Supplementary Information for Development Control Committee

17 December 2015

Agenda Item: 7 (application 5, 6 and 7)
Application Numbers: 2015/6015/P, 2015/6018/P and 2015/6016/L
Address: Coal Drops Yard, Stable Street, King's Cross Central, N1C 4AB

**Coal Drops Yard
Planning Supplementary Information**

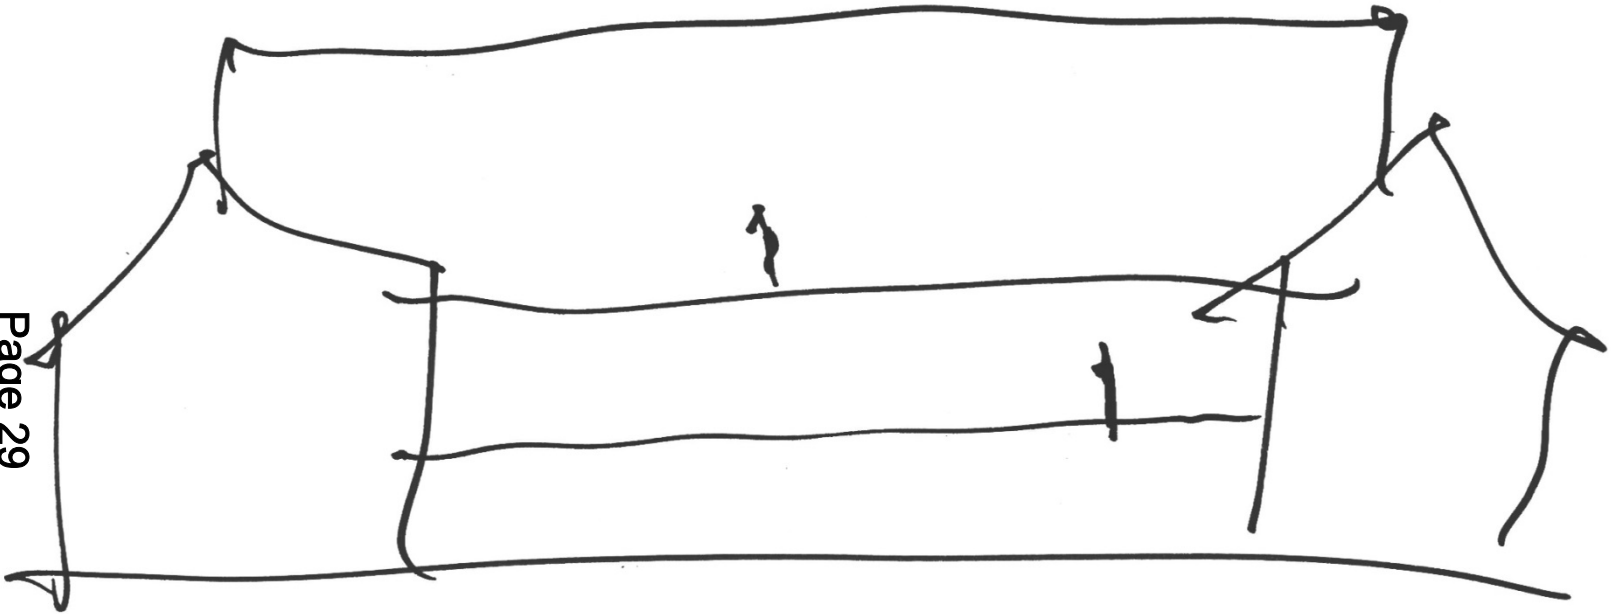
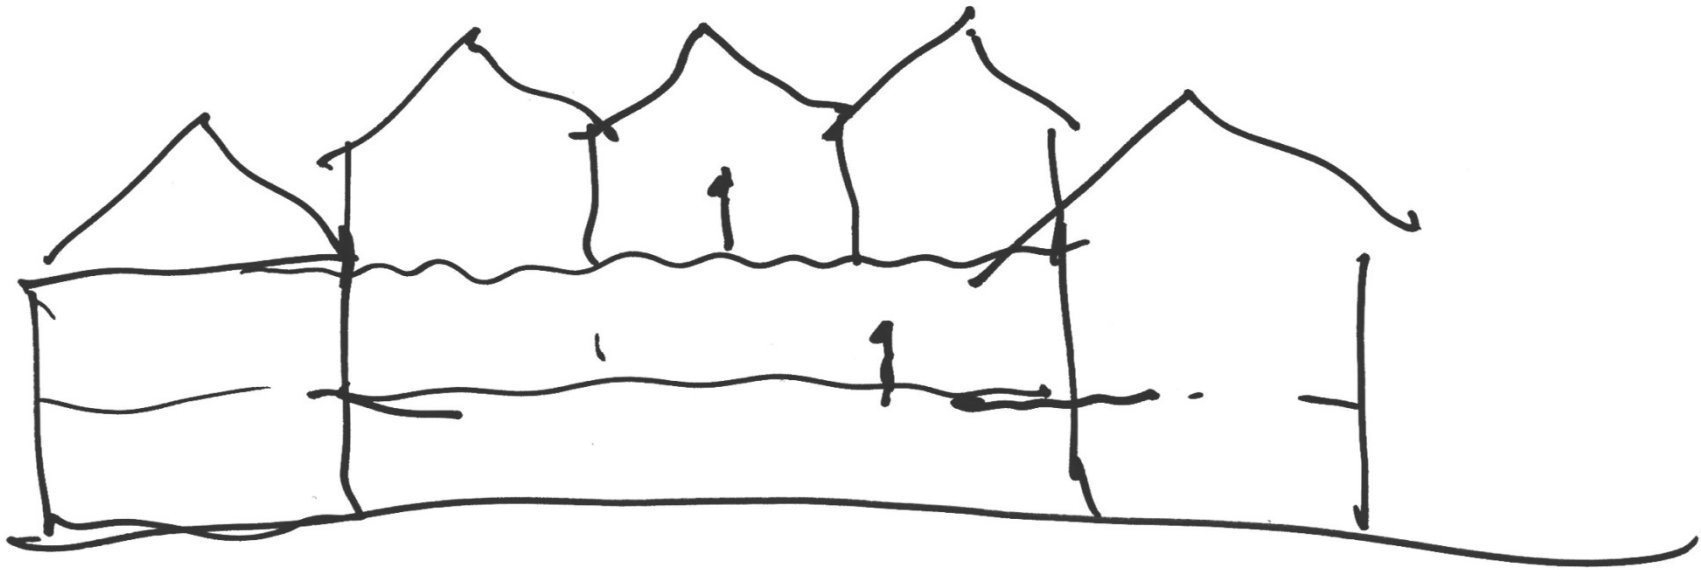
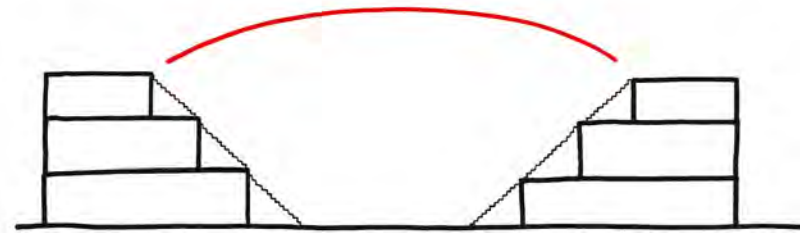
5. The Victorian Society states that "*other options do not seem to have been explored*". The Islington Society also notes that other options should be investigated and suggest that the two Coal Drops might be linked at ground level at the northern end. A range of design options have been explored as explained in Section 1.2 of the Design and Access Statement. The design team spent several months considering a wide range of options which were explored internally and with both Council officers and Historic England at a number of workshops. These workshop studies examined how we might overcome some of the challenges of the Coal Drops Yard for retailing whilst seeking to complement and enhance the heritage buildings: the existing buildings deliver a

These early studies included numerous iterations of adding massing at ground floor level within the central yard, vertically within the buildings and as part of a new upper level. These options are shown for information in the accompanying sample of imagery (compiled from pre-application discussions and workshops with stakeholders). It was considered that a new upper level best met the objectives for the proposal whilst maintaining the legibility of the heritage assets, allowing the linear form of the buildings to be read. Consequently this concept formed the basis of early pre-application discussions with officers at the Council. Subsequent workshops between Heatherwick Studios and Camden officers considered this concept further, having reviewed and discounted the earlier options.
